Planning Report

Midwestern Auto Group PUD, Subarea 2
MAG Audi, BMW & Mini
5875 and 5825 Venture Drive

Agenda Item	4
Case Number	12-072AFDP
Proposal:	A new 11,300-square-foot car dealership for the Audi franchise and the incorporation of a 1,440-square-foot, non-public car wash into the previously approved BMW/Mini building for the Midwestern Auto Group dealership campus.
Request:	Review and approval of an amended final development plan under the Planned District provisions of Zoning Code Section 153.050.
Site Location	5875 and 5825 Venture Drive. Located on the south side of Venture Drive, north of US33/SR161.
Property Owner	CAR MAG PARK LLC
Representative	Sean McCarthy, Midwestern Auto Group
Applicant	Brad Parish, Architectural Alliance
Case Manager	Claudia D. Husak, AICP, Planner II (614) 410-4675 chusak@dublin.oh.us
Planning Recommendation	<p><u>Approval of Minor Text Modifications</u></p> <p>Planning supports the minor modifications to the development text and recommends approval of the request to:</p> <ol style="list-style-type: none">1. Allow <i>three</i> wall signs in Subarea 2 and require the signs be located on the building that offers the particular brand for sale.2. Ex

Audi Wall Sign Option A	Audi Wall Sign Option B

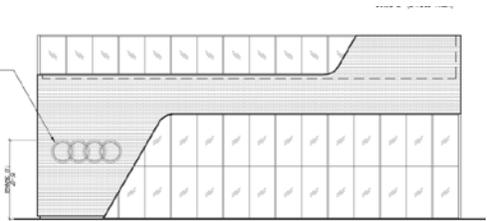
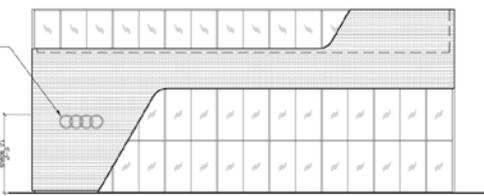
This proposal shows two options for the overall size of the proposed wall sign, consisting of the Audi logo along the west portion of the south elevation; Option A and Option B. While Planning preferred the previously proposed wall sign height of 26 feet height, the applicant has responded to the Commission’s request to lower the height to 15 feet by moving the sign to the west portion of the front elevation.

The applicant has indicated that the Audi sign is available in the two sizes shown. Option A is the applicant’s preferred version but exceeds 50 square feet. Option B meets the 50 square foot limit of a wall sign.

Planning prefers Option A as its size provides a better visual balance given the proposed location but requests the sign size be decreased to 50 square feet. Therefore, Planning supports the text modifications for wall signs, as summarized below (refer to modified development text for detailed language):

1. Allow *three* wall signs in Subarea 2 and require the signs be located on the building that offers the particular brand for sale.
2. Exempt logos from the *size restrictions of 20%* of the permitted signs size or 10 square feet.
